***Planning Department
Transportation Development Services***

**Re: Central & Atrisco Façade Remodel, 4010 Central Ave. SW
Traffic Circulation Layout**
Architect's Stamp dated 05-07-14 (K12-D033)

Based upon the information provided in your submittal received 07-17-14, the above referenced plan cannot be approved for Building Permit until the following comments are addressed:

SITE PLAN
1" = 20'-0"

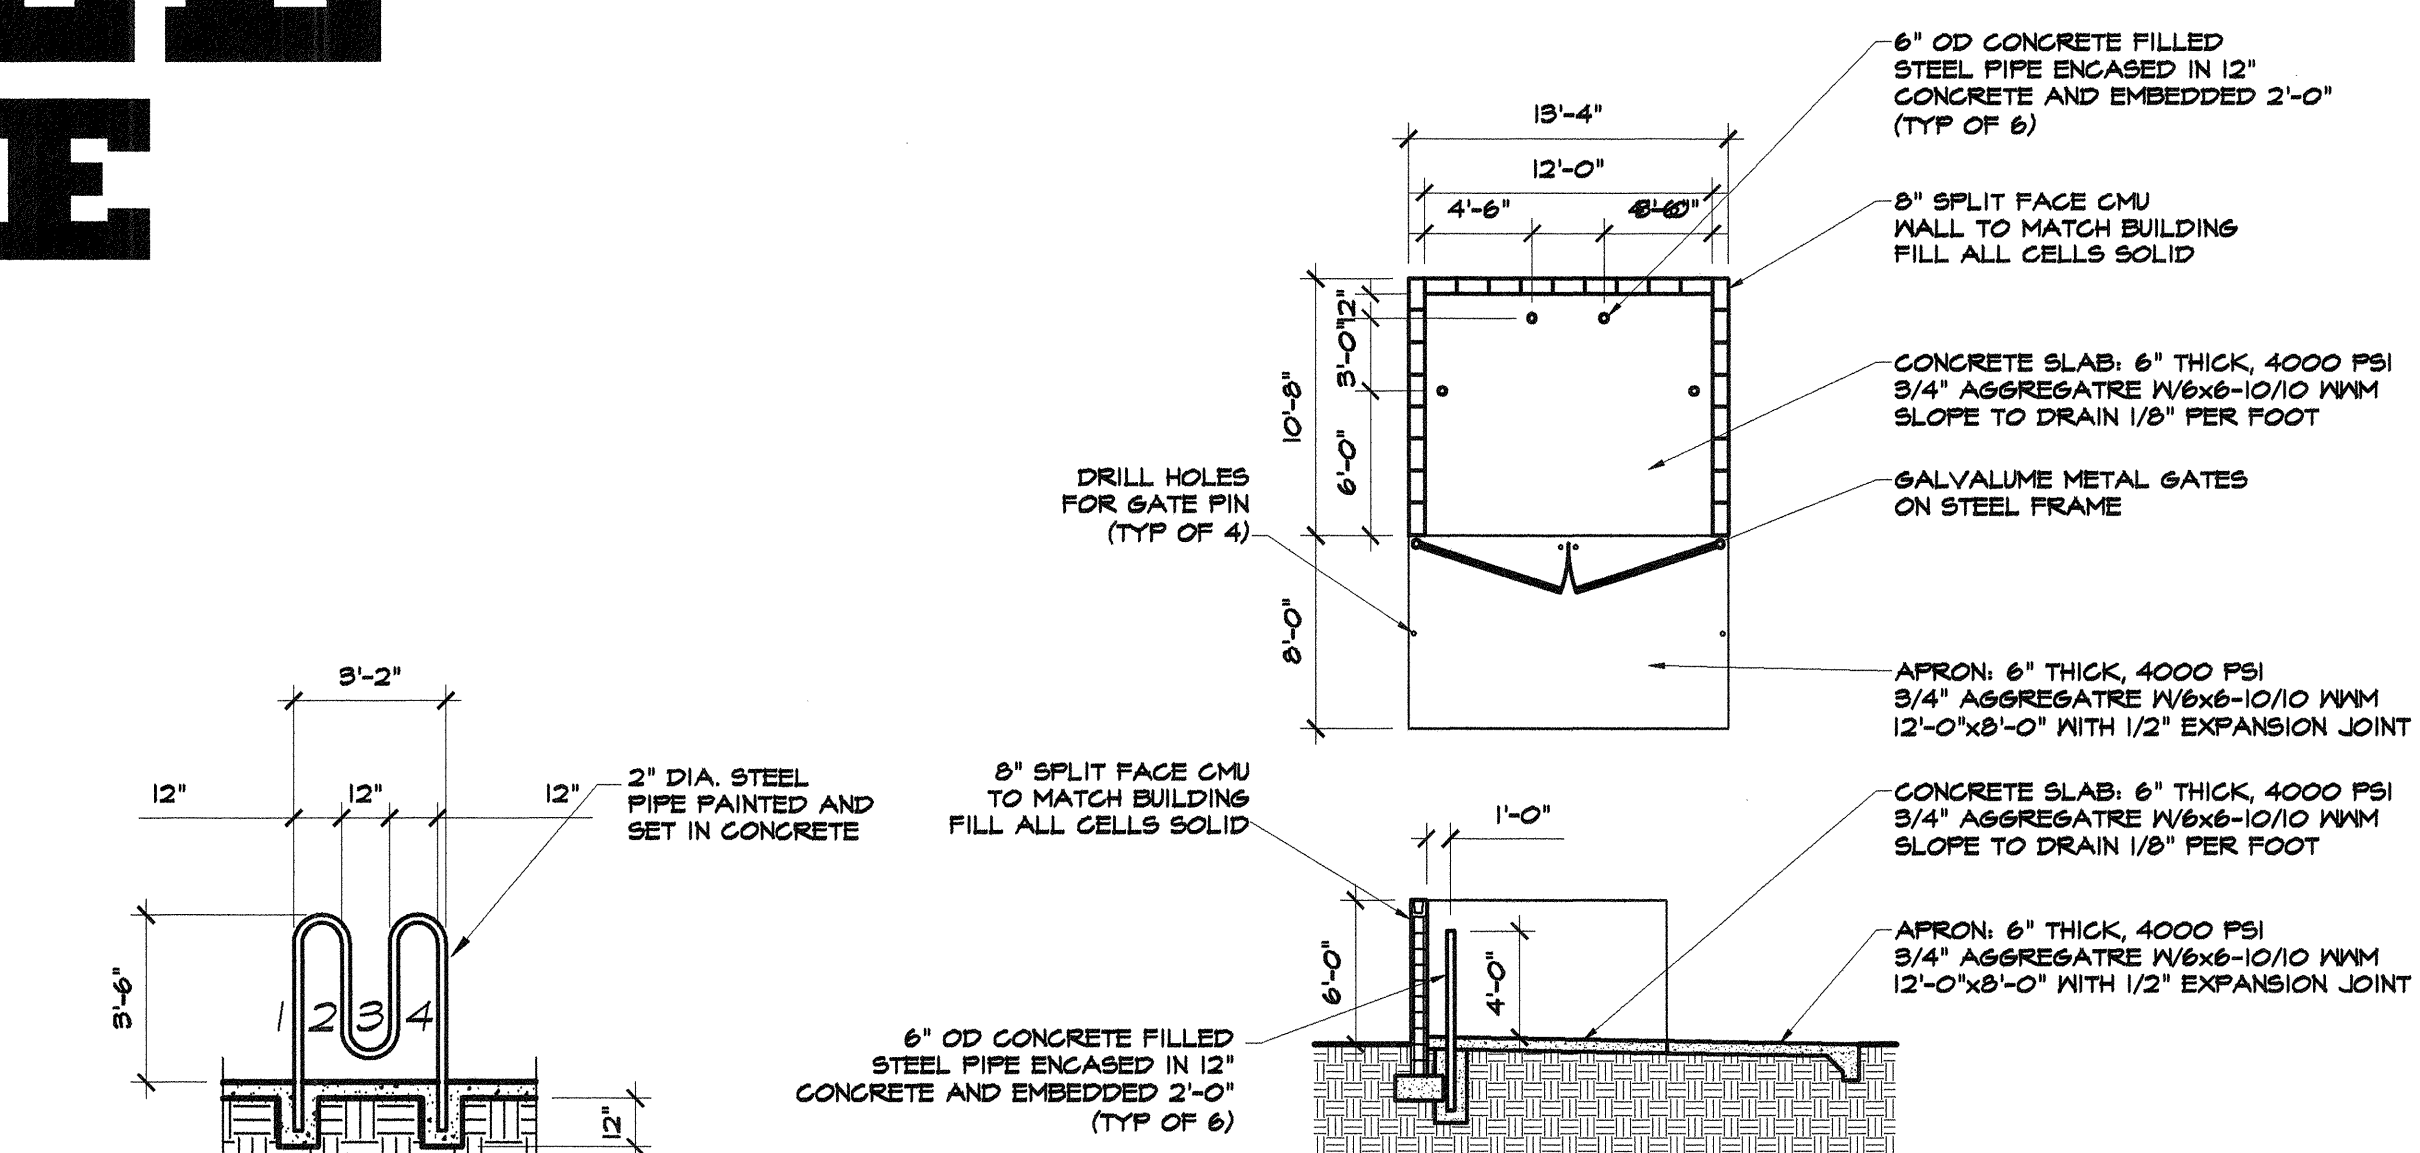
- PO Box 1293
Albuquerque
New Mexico 87103
www.cabq.gov
1. NMBC Table 1106.1 requires 4 ADA accessible parking spaces one of which needs to be Van accessible.

2. Please identify all existing buildings, doors, structures, sidewalks, curbs, drive pads, walls and anything that influences the parking and circulation on the site.

3. Identify the right of way width, medians, curb cuts, and street widths on both sides of the street.
 4. Please list the width and length for all parking spaces.

5. Parking spaces cannot cross over the lot lines.
 6. The ADA accessible parking sign must have the required language per 66-7-352.4C NMSA 1978 **"Violators Are Subject to a Fine and/or Towing."**

7. The ADA access aisle shall have the words **"NO PARKING"** in capital letters, each of which shall be at least one foot high and at least two inches wide, placed at the rear of the parking space so as to be close to where an adjacent vehicle's rear tire would be placed. (66-1-4.1.B NMSA 1978)

8. Show all drive aisle widths and radii.
 9. List radii for all curves shown; for passenger vehicles, the minimum end island radius is 15 feet. Landscape island radius for delivery trucks, fire trucks, etc. is 25 feet or larger

10. Per the DPM, a 6 ft. wide ADA accessible pedestrian pathway is required from the public sidewalk to the building entrances. Please clearly show this pathway and provide details.

11. All sidewalks along streets should be placed at the property line.
12. Provide a min 6" or max 8" high concrete barrier curb or other acceptable barrier between landscaping and parking areas and/or drive aisles.

13. Design delivery vehicle route needs to be shown.
14. Service vehicle and/or refuse vehicle maneuvering must be contained on-site.
15. It is not apparent what type of pavement surface is being proposed. A hard driving surface will be required as part of this proposed project for parking area and drive aisles.

16. Please add the following note to the clear sight triangle: "Landscaping and signage will not interfere with clear sight requirements. Therefore, signs, walls, trees, and shrubbery between 3 and 8 feet tall (as measured from the gutter pan) will not be acceptable in this area."

17. Please specify the City Standard Drawing Number when applicable.
18. Work within the public right of way requires a work order with DRC approved plans.

19. Unused curb cuts must be replaced with sidewalk and curb & gutter. A build note must be provided referring to the appropriate City Standard Drawing.

20. Please include two copies of the traffic circulation layout at the next submittal.
